PRODUCT CHANGE NOTIFICATION (PCN)

A-MCSSP-80005/G
MODULAR CABLE

CHANGE NOTIFICATION: PCN 20220425_A-MCSSP-80005/G

ASSMANN WSW P/N	Drawing Number		ASSMANN WSW P/N	Drawing Number
A-MCSSP-80005/G	ASS_0841_CArev00	↔	A-MCSSP-80005/G	ASS_0841_CArev01

A-MCSSP-80005/G OLD VERSION

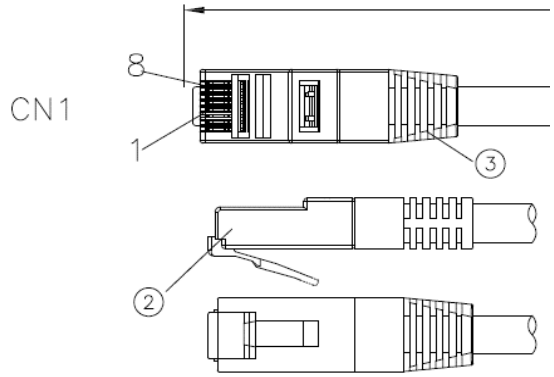
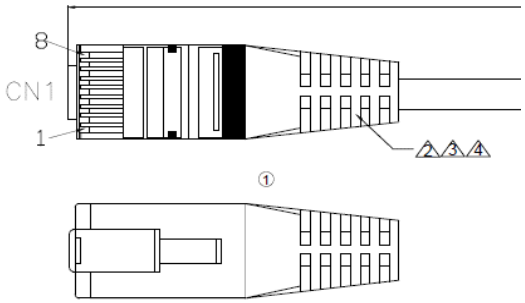
DESCRIPTION OF CHANGES:
CHANGE OF DATA SHEET
CHANGE OF DATA SHEET
New Draw.-No. ASS_0841_CArev01

REASON FOR CHANGE:
CHANGE OF PRODUCT LOCATION
CHANGE OF PRODUCT LOCATION

NO.	NAME.	Q'TY	SPECIFICATION
③	Molding PVC	2	Molding PVC 45P
②	RJ45 CONN	2	RJ45 8P8C,Two Fork gold plated contacts 3u" gold
①	CABLE	1	SFTP(26AWG*x1PR)*4+AB,PVC OD:5.3±0.3mm

NO.	NAME.	Q'TY	SPECIFICATION
①	4	AL-Foil	2	Double-sided conductive aluminum foil
①	3	Molding PVC	2	Molding PVC 65P
①	2	RJ45 CONN	2	RJ45 8P8C,Two Fork gold plated contacts 3u" gold Shielded
①	1	CABLE	1	SF/UTP(26AWG*x1PR)*4+AB(AL-MY),PVC OD:5.3±0.3mm

Drawing-No.
ASS 0841 CA

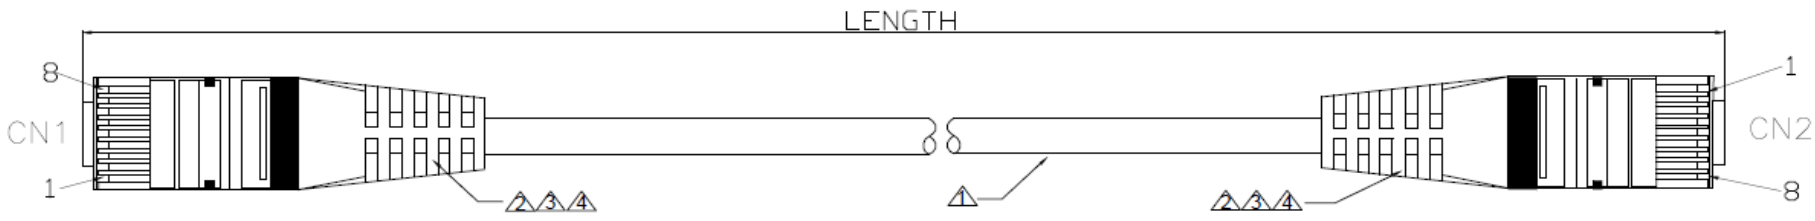
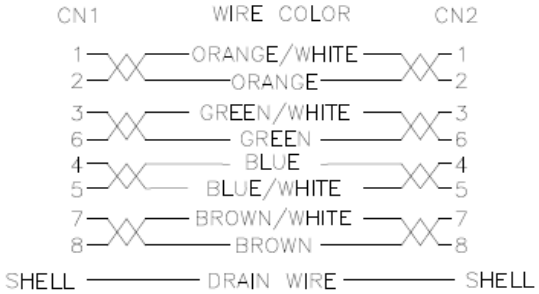
Id.	Modification	Date	Name
①	Change the plant	12.04.2022	Luca
⓪	Drawn	04.08.2017	Fred

NO.	NAME.	Q'TY	SPECIFICATION
①	4		AL-Foil	2	Double-sided conductive aluminum foil
①	3		Molding PVC	2	Molding PVC 65P
①	2		RJ45 CONN	2	RJ45 8P8C,Two Fork gold plated contacts 3u" gold Shielded
①	1		CABLE	1	SF/UTP(26AWG*x1PR)*4+AB(AL-MY),PVC OD:5.3±0.3mm
